WARRANTY BULLETIN

WB23-01

SUBJECT: IMPROPER VEC(F) POWER DISTRIBUTION

Figure 1: VEC unit location in front junction box (also shown AE41 & AE42 affected modules).

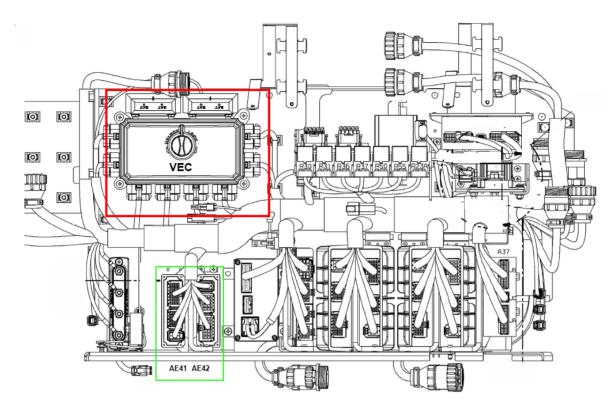
The vehicles affected by this bulletin may have been equipped with an improper front VEC unit, specifically, the multiplex modules AE41 & AE42 are possibly feed from the VEC with 12VD instead of 24V WUP.

- 1. Open the vehicle front electrical compartment (front junction box) and locate the VEC unit (figure 1).
- 2. Open the VEC cover and validate the **Prevost part number** located at the right of the unit (position 1 in figure 2) part number must be **560531**.
- 3. Power up the vehicle electrical system and check that:
 - F34 fuse is a 5A fuse (position 2 figure 2).
 - F34 fuse circuit is powered by 24V Wake-up (wake-up = must stay powered for 15 min after ignition shut-off).
- 4. If the VEC fails the tests at step 3, it must be replaced (order new VEC part # 560531).

Therefore, all listed vehicles must have their front VEC verified following the procedure below and replaced as needed.
